North Central Industrial Park

RESUBDIVISION OF LOTS 11 & 12
PART OF SECTION 30, T. 47 N., R. 5 E., ST. CHARLES COUNTY, MISSOURI
(Recorded in Bl. 30, Pg. 74)

FILE COPY
APPROVED AS NOTED
4-25-91
Frank Gehring
APPROVED
DATE 3/19/91
P & Z

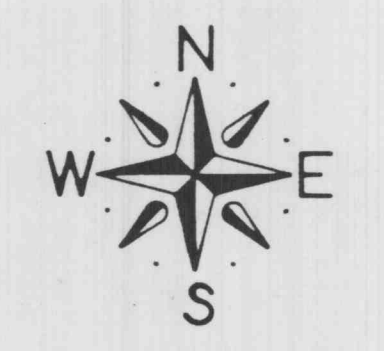
Developer or owner shall obtain an offsite easement for grading of swale across Lot 11A to existing area inlet. (as shown on PE4's plans)

Swale
0.75' deep
4' wide
